NOTICE OF ADDENDUM  
ADDENDUM NO. 2  
CONTRACT NO. 8119

S. BRYAN STREET, DALEY DRIVE, JAMES STREET AND THORP STREET  
RECONSTRUCTION DISTRICT – 2018

**Addendum #1 referenced several plan sheets that were not attached to the addendum. See attached for the revised plan sheets.**

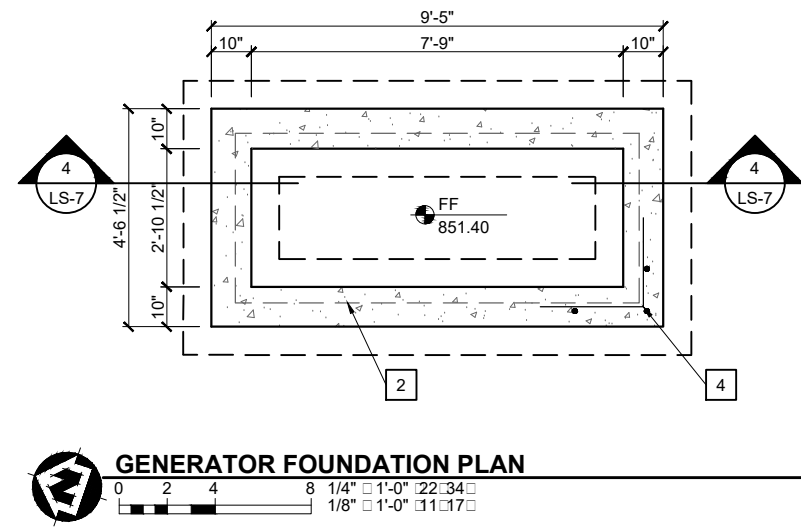
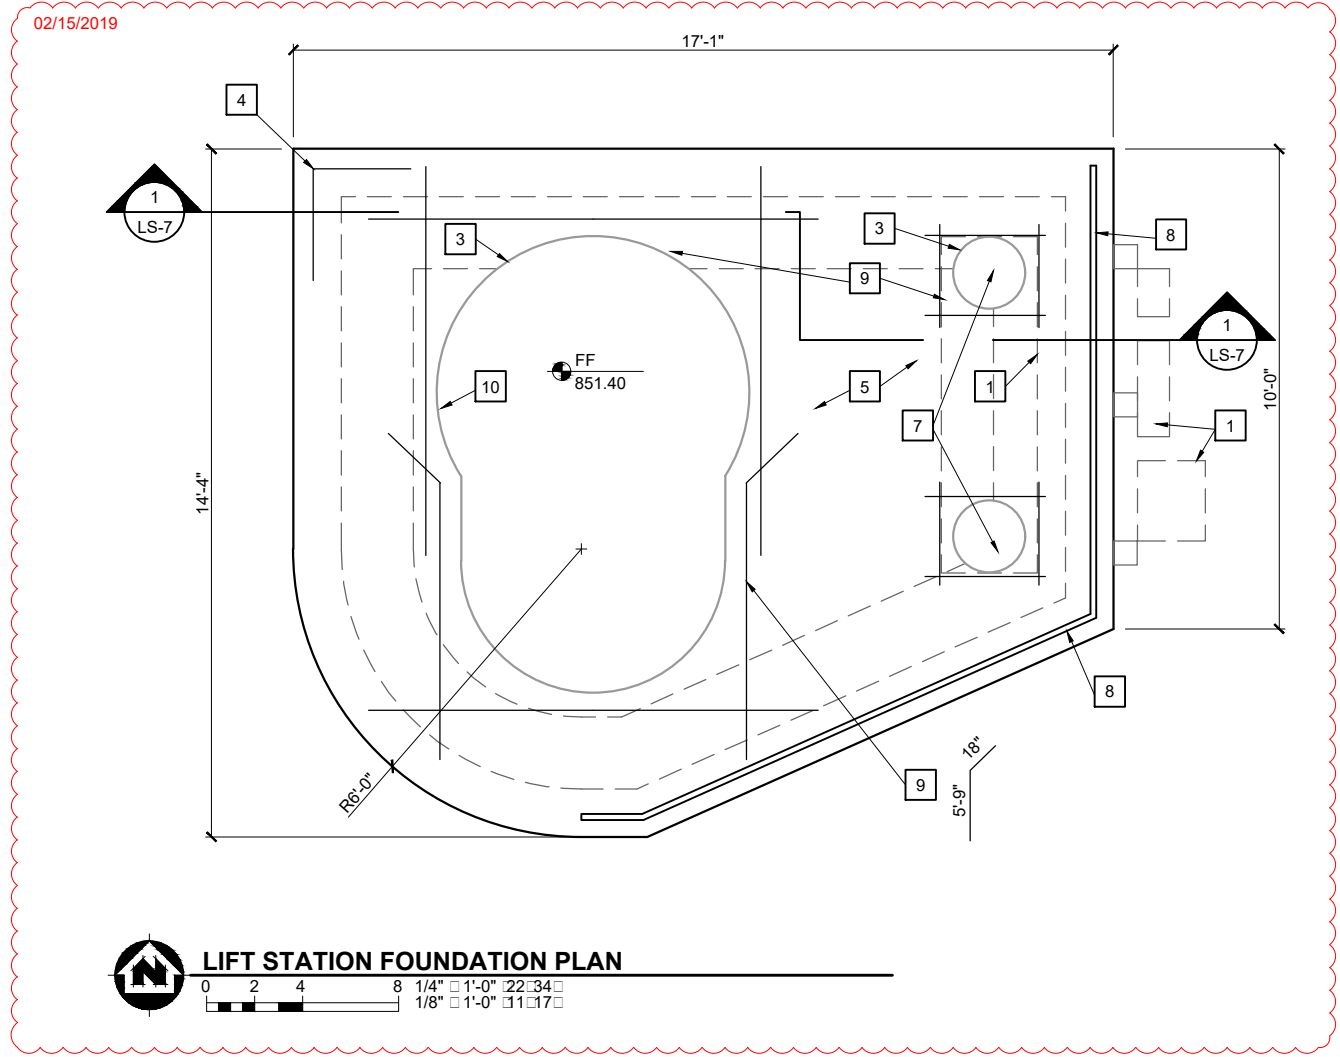
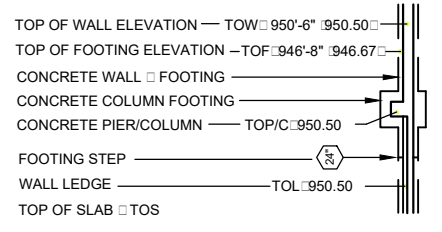
REVISED 02/15/2019 TKM  
 • REVISED KEY NOTES PER LIFT STATION FOUNDATION PLAN EDITS.  
 • REVISED LIFT STATION FOUNDATION PLAN PER CITY COMMENTS.

- 12" THICK REINFORCED SLAB W/ THICKENED EDGES OVER MIN. 12" COMPACTED GRAVEL FILL AND COMPACTED GRANULAR FILL 02/15/2019
- NOTE NOT USED.** 02/15/2019
- CONTROL PANEL SUPPORTED ON SONOTUBE FOUNDATIONS. SEE TYPICAL DETAIL FOR FREE STANDING CONTROL PANEL MOUNTING ON SHEET LS-22 02/15/2019

- HOT-DIP GALVANIZED STEEL GUARDRAIL AND POSTS - SEE DETAILS: 2/LS-7 AND 3/LS-7 02/15/2019
- REBAR AROUND ELECTRICAL OPENING, ADDITIONAL #6 BARS AROUND SLAB OPENINGS AND AROUND SONOTUBE FOUNDATIONS PENETRATING SLAB. MAINTAIN MINIMUM CLEARANCE. BAR LENGTHS EQUAL TO DIAMETER OF OPENING 36" U.N.O. 02/15/2019

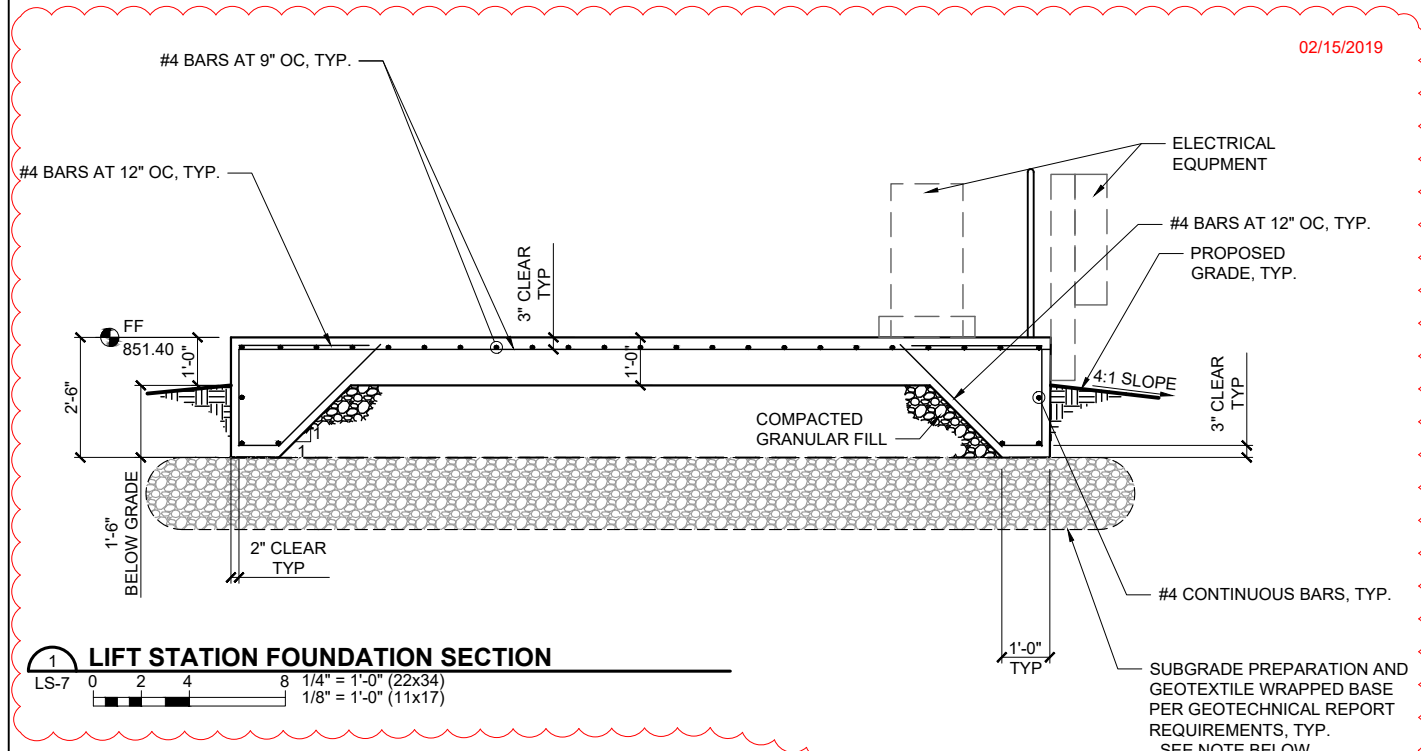
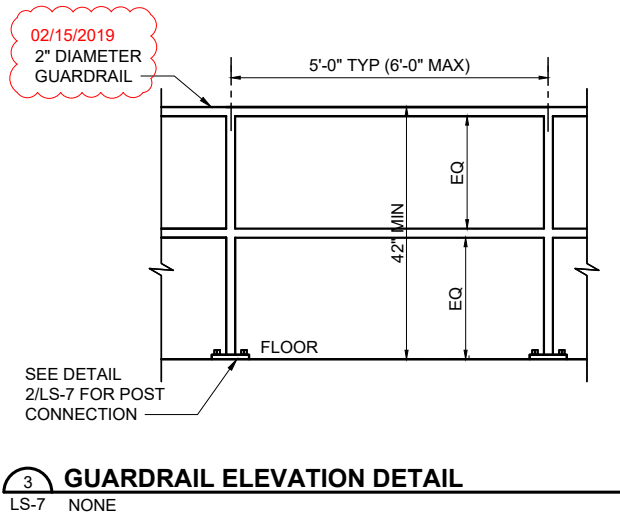
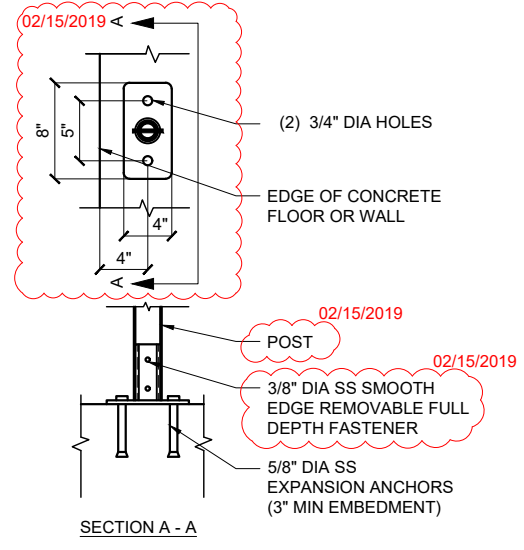
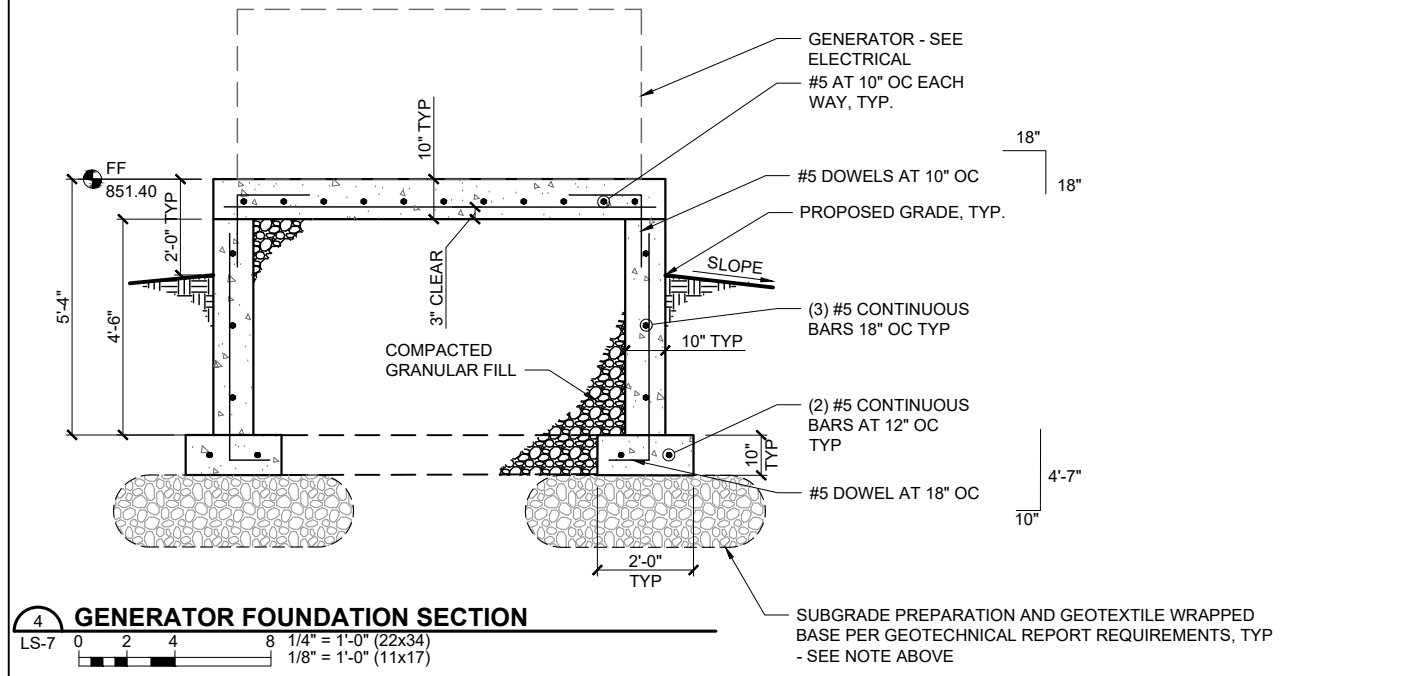
- REVISED 02/15/2019 TKM
- REVISED LIFT STATION FOUNDATION SECTION 1/LS-7 PER CITY COMMENTS.
  - REVISED TYP REMOVABLE POST MOUNTED DETAIL 2/LS-7. REMOVED TOE-PLATE AND REVISED POST TO GO OVER TOP OF MOUNTING PLATE VERTICAL MEMBER.
  - REVISED GUARDRAIL ELEVATION DETAIL 3/LS-7. CHANGED DIAMETER OF GUARDRAIL.
  - REMOVED TYPICAL SLAB ON GRADE (CJ) DETAIL 5/LS-7.

PROPOSED LIFT STATION SITE PLAN  
JAMES STREET CITY OF MADISON

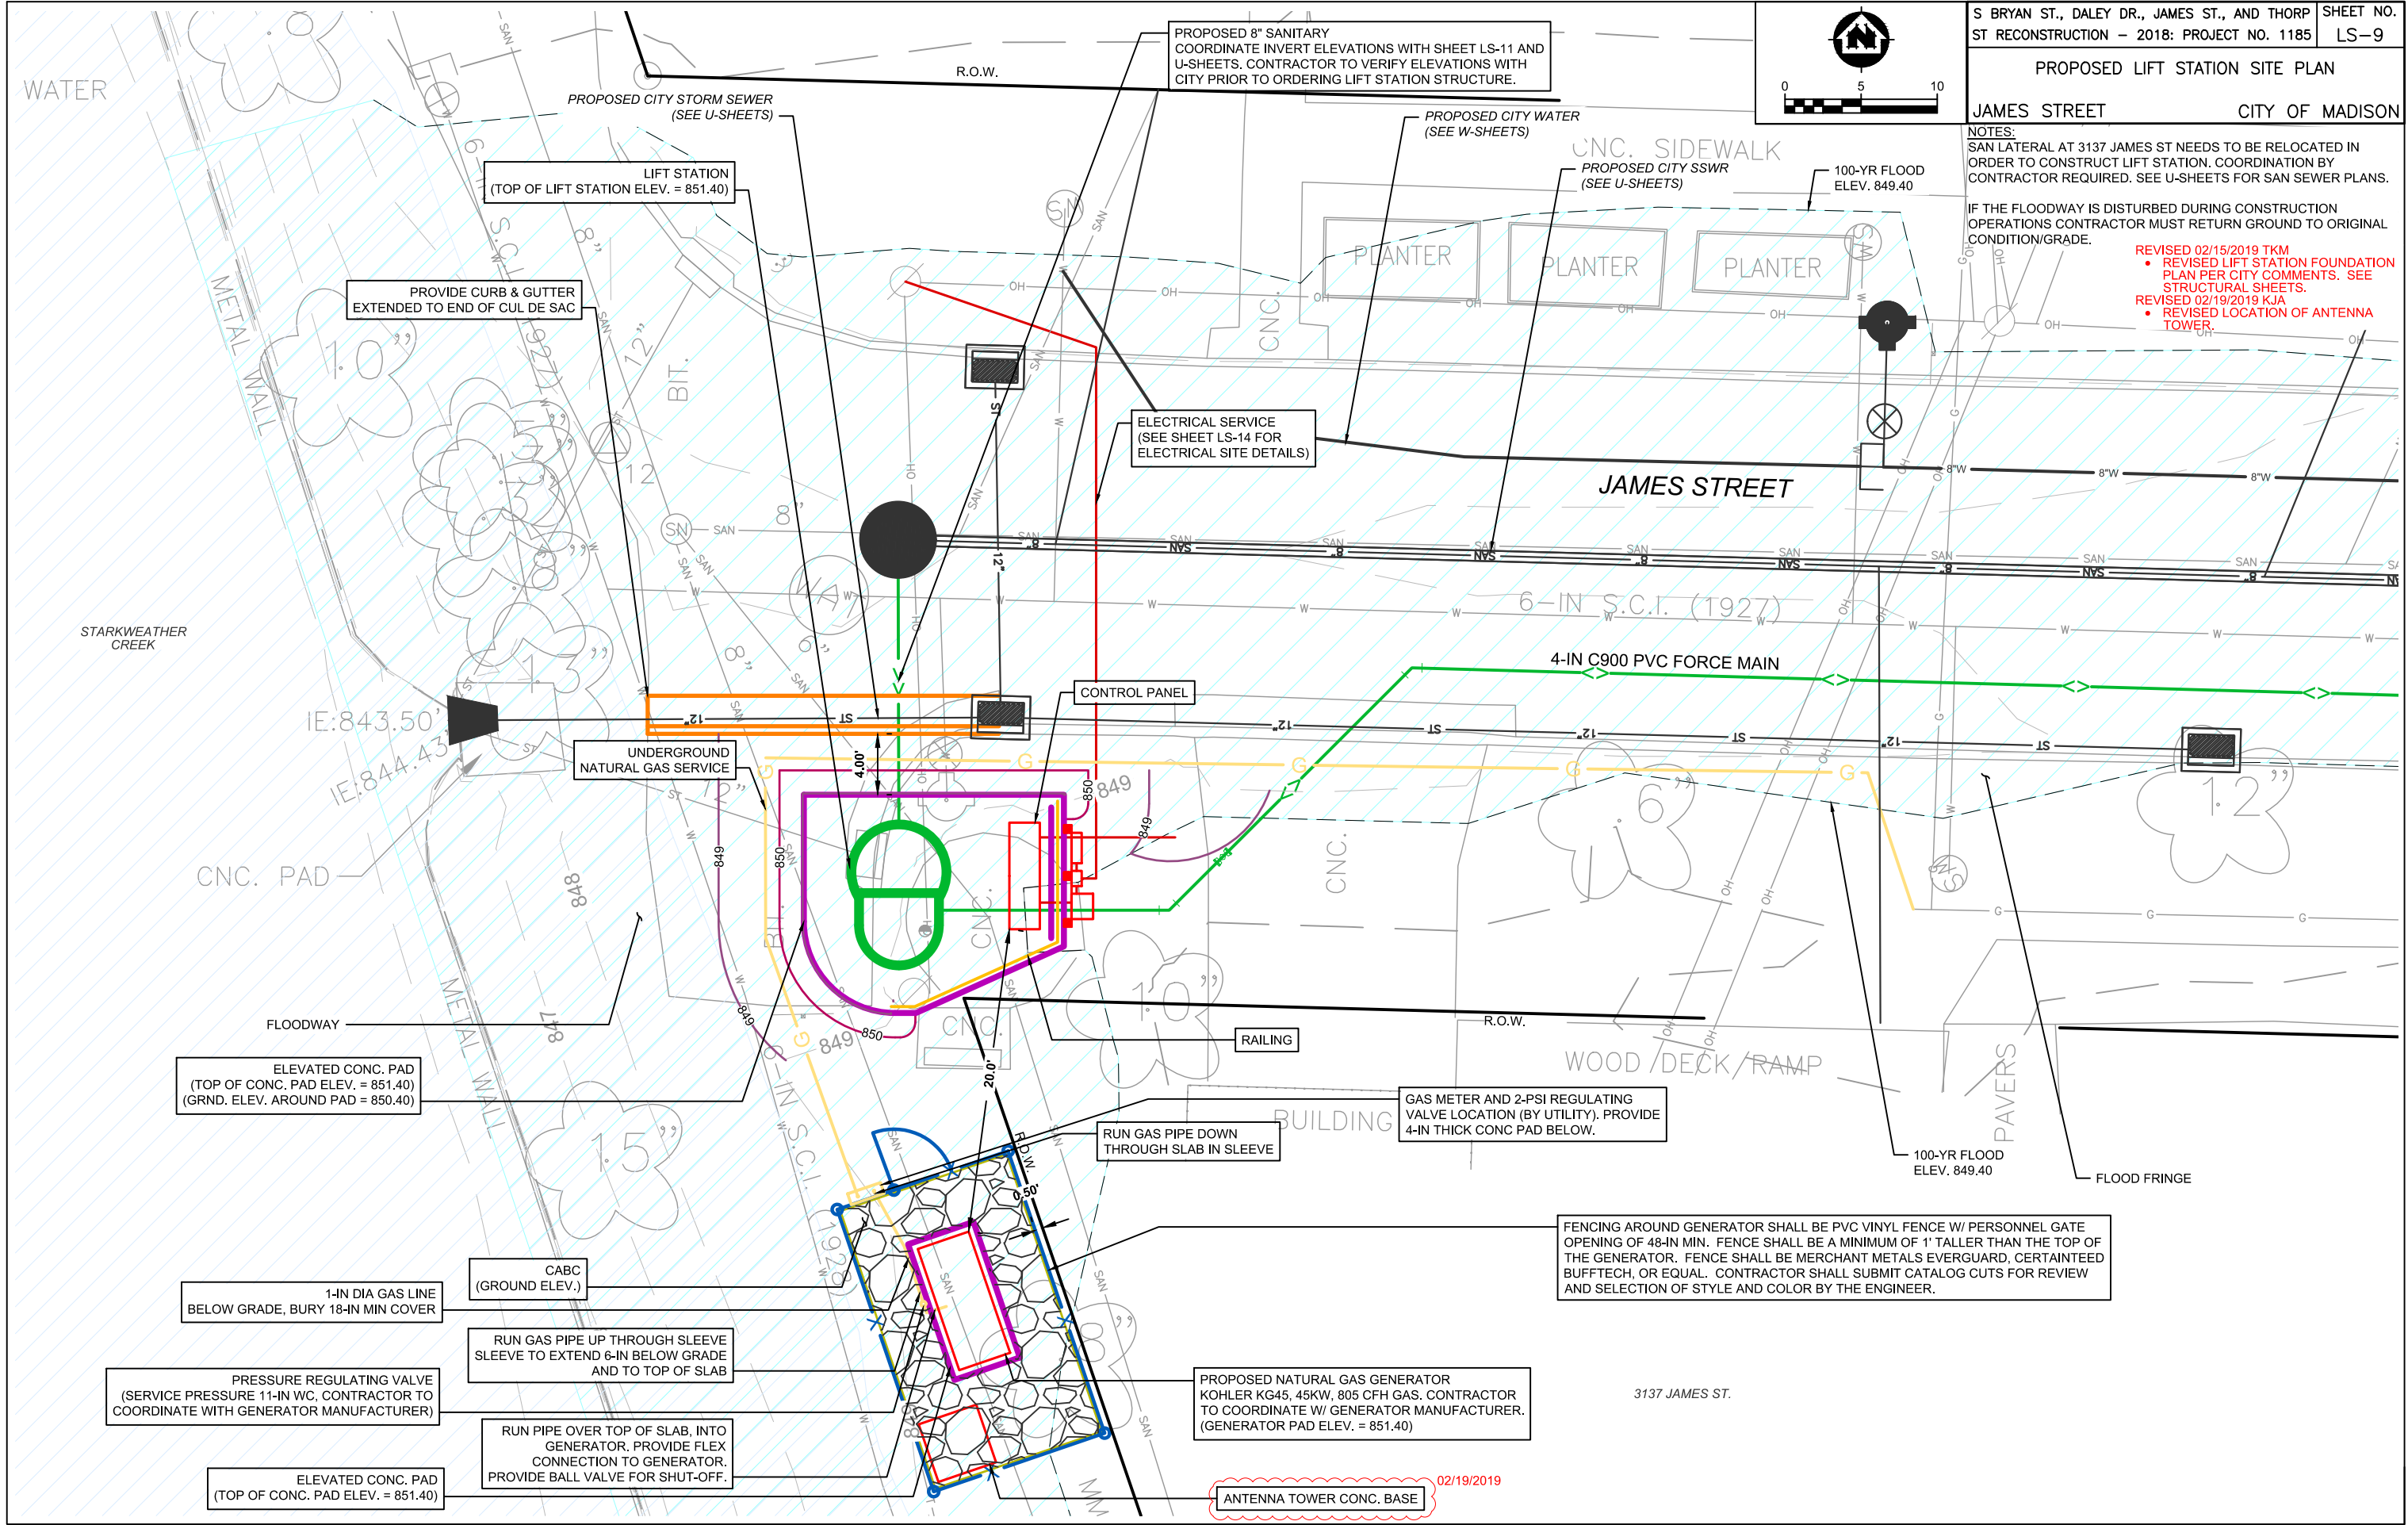
- REVISED 02/15/2019 TKM
- REVISED LIFT STATION FOUNDATION PLAN PER CITY COMMENTS. SEE STRUCTURAL SHEETS.
- REVISED 02/19/2019 KJA
- REVISED LOCATION OF ANTENNA TOWER.
